UNITED STATES PATENT AND TRADEMARK OFFICE

APPLICATION NO.	FILING DATE	FIRST NAMED INVENTOR	ATTORNEY DOCKET NO.	CONFIRMATION NO.
10/774,272	02/06/2004	Christoph Andreas Roth	008932-0876-999	8488
51832	7590	11/01/2005		
JONES DAY 222 EAST 41ST STREET NEW YORK, NY 10017-6702			EXAMINER SWIGER III, JAMES L	
			ART UNIT	PAPER NUMBER

Office Action Summary	Application No. 10/774,272	Applicant(s) ROTH ET AL.	
	Examiner James L. Swiger	Art Unit 3733

DETAILED ACTION

Figure 1.

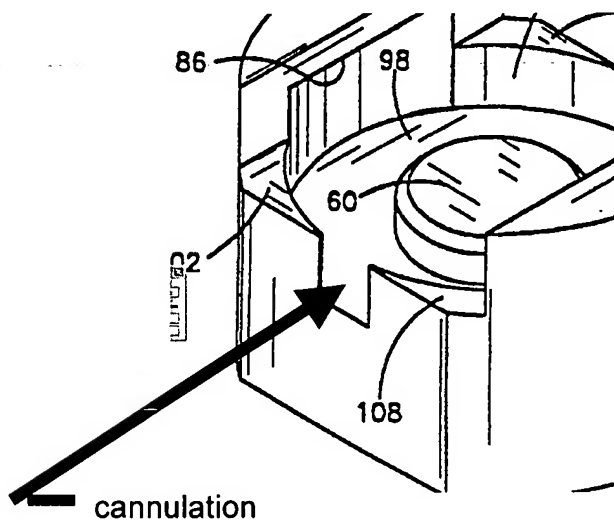
Claims 1-4, 6,9,10-12,13-19,20-22,30-32 are rejected under 35 U.S.C. 102(b) as being anticipated by Asher et al (U.S. Patent No. 5,257,993). Asher et al. discloses a device having a mechanism (Fig. 1) comprised of a body member (22), a single prong (28), and a drive member (60a). The device of Asher et al. is also capable of having a first and second engagement surface and is capable of a location within a longitudinal channel and tabs (68a and 70a). The disclosed device also has a bore area (32a), and a substantially cylindrical portion (26a). The device of Asher et al. also discloses a drive member that is rotatable (Col. 7, line 42) and functions with an end cap (24). Finally, Asher et al. discloses a cannulation for use in a guidewire (See Fig. 1 below).

Fig. 2

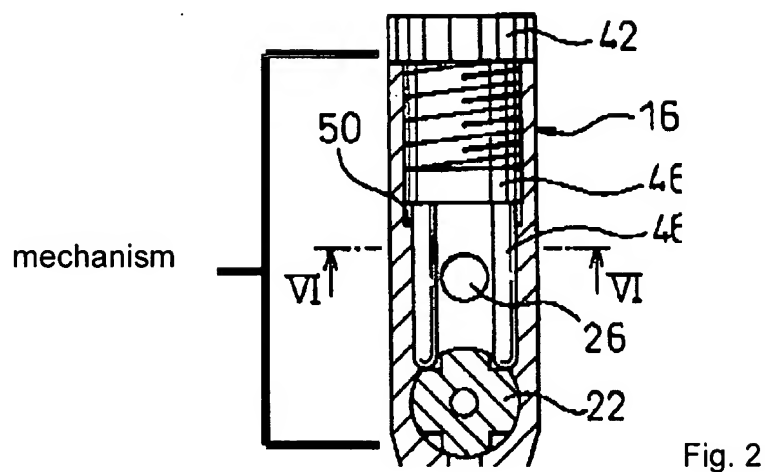
Claims 1-9,13-18 and 23-29,33-34 are rejected under 35 U.S.C. 102(e) as being anticipated by Fujiwara (U.S. Patent No. 6,406,477). For claims 1-9,13-18, Fujiwara discloses a device having a mechanism (See Fig. 2 below).

Fujiwara also discloses a device having a body member (46a), a single prong (46), drive member (40), a first and second engagement surface (Fig. 2), a longitudinal channel (16b), stops (34), a bore (26), a predetermined angle with the first longitudinal axis (see Fig. 3 below), a drive member (42) that is rotatable and threadably engages the first implant, and has an end cap (top section of 42).

Figure. 3

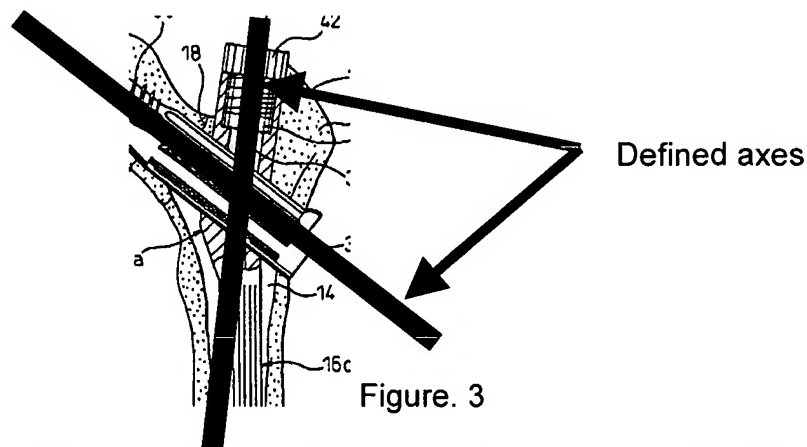
sliding of the second implant. The word "substantially" functions as an indefinite term in this situation, and is examined in the broadest reasonable interpretation. The mechanism also extends through a bore in the first implant at the intersection of the axes in Fig. 3, and an end cap (top of 42).
